REPORT OF ALTERATIONS TO DESIGNATED RESOURCE

Site Number/Address: 421 E. Laurel St.

Laurel School National Register Historic District

This report is to document proposed alterations to the Jackson Norris House at 421 E. Laurel Street, pursuant to Fort Collins Municipal Code Chapter 14, [Article IV](#). A copy of this report may be forwarded to the Colorado Office of Archaeology and Historic Preservation.

2 (E) South Elevation
1/4" = 1'-0"

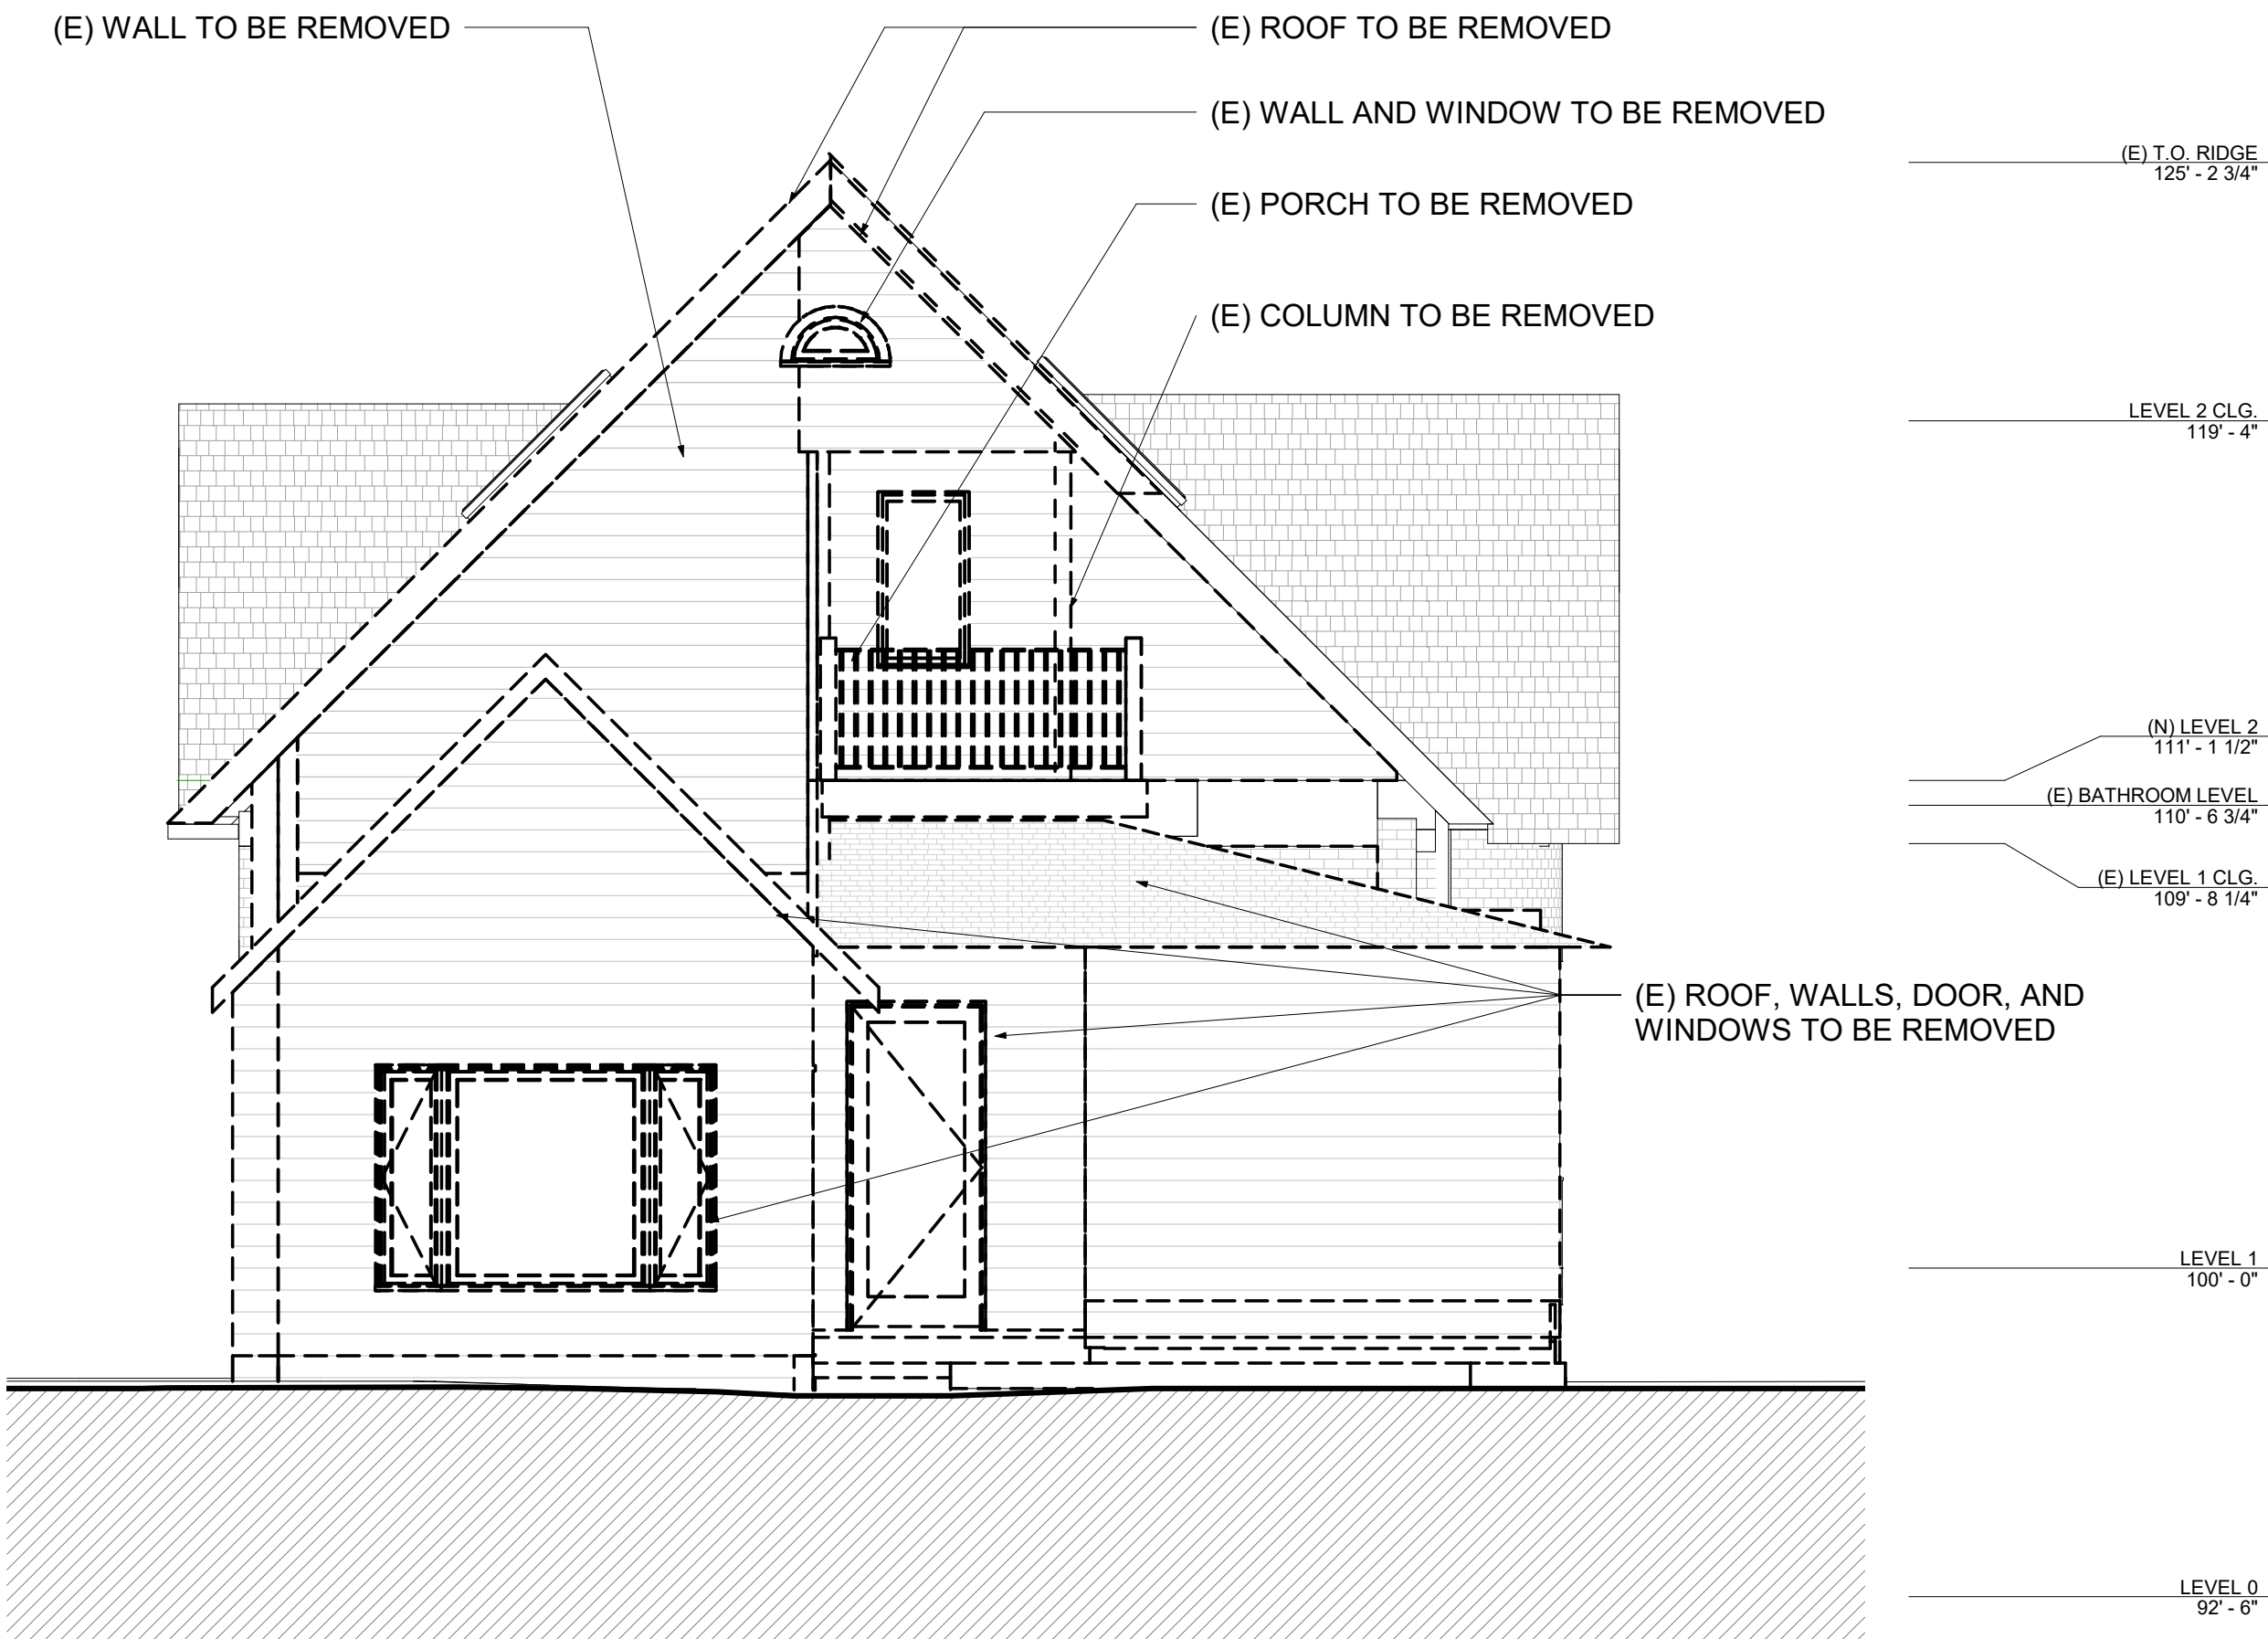
- The main note we'd offer is to minimize alteration of the rear/south gable end. Our top recommendation would just be to retain the existing fish-scale shingles and window. The next best thing would be to replace the siding with something similar and at least keep the window in its current location.
